Service Bulletin 4812 718 40309**AUTHOR:** Alicja Malinowska**Last Update:** 03/30/11**VERSION:** 1.0**TITLE:** Integrated heating element Euro/UK (Motor Pump Heater MPH)**SUBJECT:** Integrated heating element Euro/UK replacement**REMEDIAL ACTION**

Service Bulletin 4812 718 40316

TITLE: Open Fuse occurring at integrated heaters used for Motor-Pump-Heater (MPH), and Variable Speed Motor (VSM).

SUJET : Fusible de résistance fondue

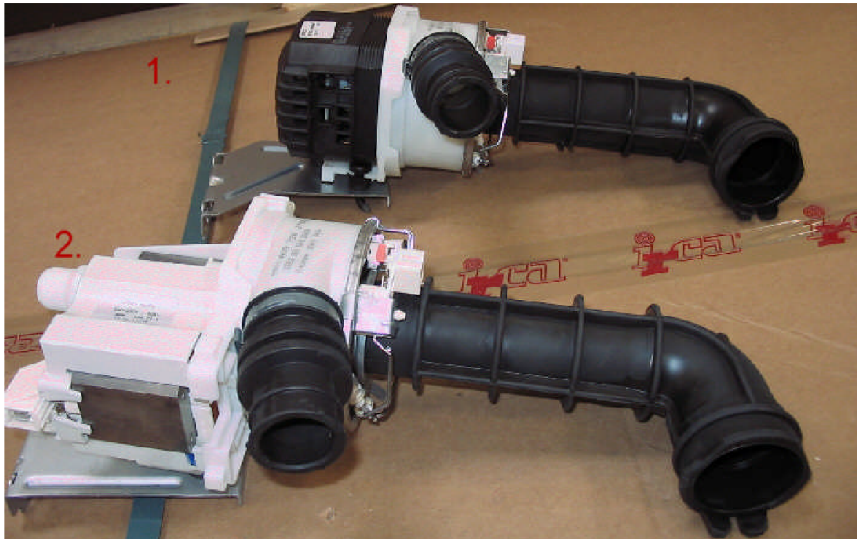
In case of intervention related to open fuses at integrated heaters for motors MPH and VSM and visible lime stone deposition on heating element please follow below described procedure:

All appliances using heater integrated with motors (Single Speed (MPH), Variable Speed (VSM)).

On the picture above motors with integrated heaters are shown:
1. Variable Speed Motor (VSM), 2. Single Speed Motor (MPH).

In case of heater replacement due to open thermal fuse, when inside heater can be found calcium/limestone layer caused by hard water please check if:

Calcium/limestone deposition that builds up on heater is limiting heat transfer from heater to water and forcing thermal protectors to react. In longer time the irreversible protector is tripped. Reducing/eliminating calcium (caused by not softened water) build-up will avoid such cases.

1. Water hardness setting on Dishwasher is correctly set, if necessary increase water hardness setting.
2. In case of multifunction detergent (tablets "X" in 1) used in area with hard water, instruct customer that salt has to be added in addition to multifunction detergent.

Correct setting, customer instruct and proper usage of Softener will avoid calcium/limestone buildup and help avoiding multiple service visits.

4801 310 00096

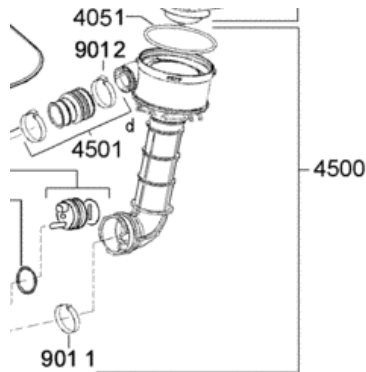
- suite à des surcharges de produits lessiviels, il peut arriver que des résidus de lessive viennent petit à petit réduire les performances de la pompe de cyclage ce qui provoque une surchauffe de la résistance 481225928925 remplacé par : 480131000096. (Fusible fondu). Dans ce cas particulier, il est recommandé de changer la pompe de cyclage en plus de la résistance.

Dans ce cas particulier, il est **recommandé de changer** :

En plus de la résistance : **4801 310 00096** →

- La Pompe de Cyclage : **4801 401 02394**

Vous trouverez ci-dessous deux représentations différentes de ces pièces dans les SM.

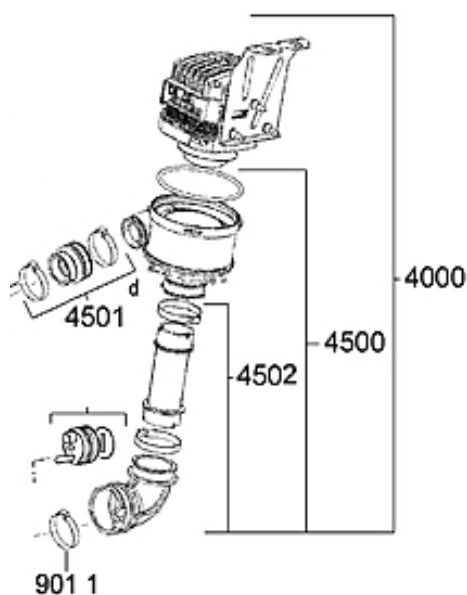
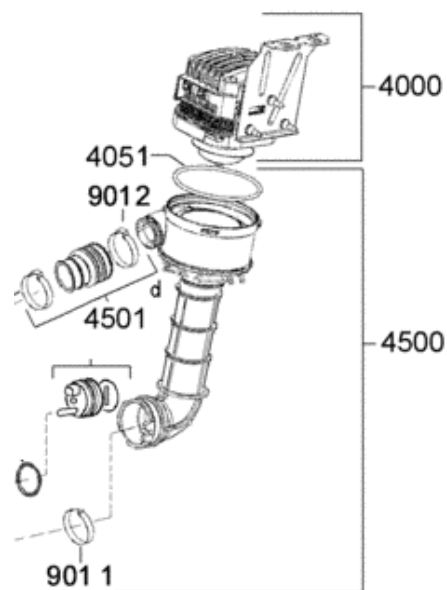
Code service de la résistance 4812 259 28925 remplacée par : 480131000096.
Si vous commandez ce code vous recevrez uniquement :

- suite à un problème sur le relais de chauffage la résistance est alimentée à vide. Pour tester le relais de chauffage mettre l'appareil sous tension, fermer la porte de l'appareil et prendre la tension aux bornes de la résistance. En l'absence de l'alimentation de la bobine du relais de chauffage, une tension totale ou partielle aux bornes de la résistance est significative d'un relais défectueux. Dans ce cas particulier, il est recommandé de changer le relais de chauffage en plus de la résistance.

Représentation d'un montage complet

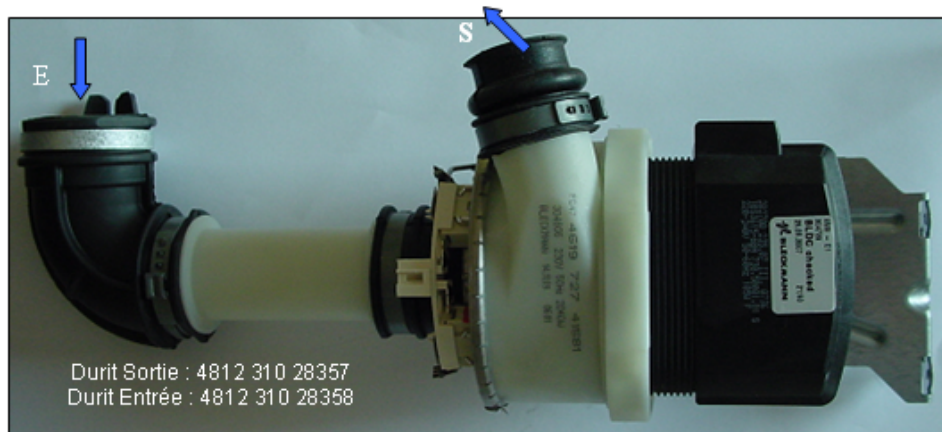
REP 4000	Code service MOTEUR kit VSM	Remplacée par	Remplacée par	Code dispo après épuisement 2 autres
	4812 361 58457	4812 361 58513	4801 310 00119	4801 401 02394 (461972628021)
REP 4500	Code service RESISTANCE	Remplacée par	Remplacée par	Code service Actuel
	4812 259 28925			4801 310 00096 (461972775402)
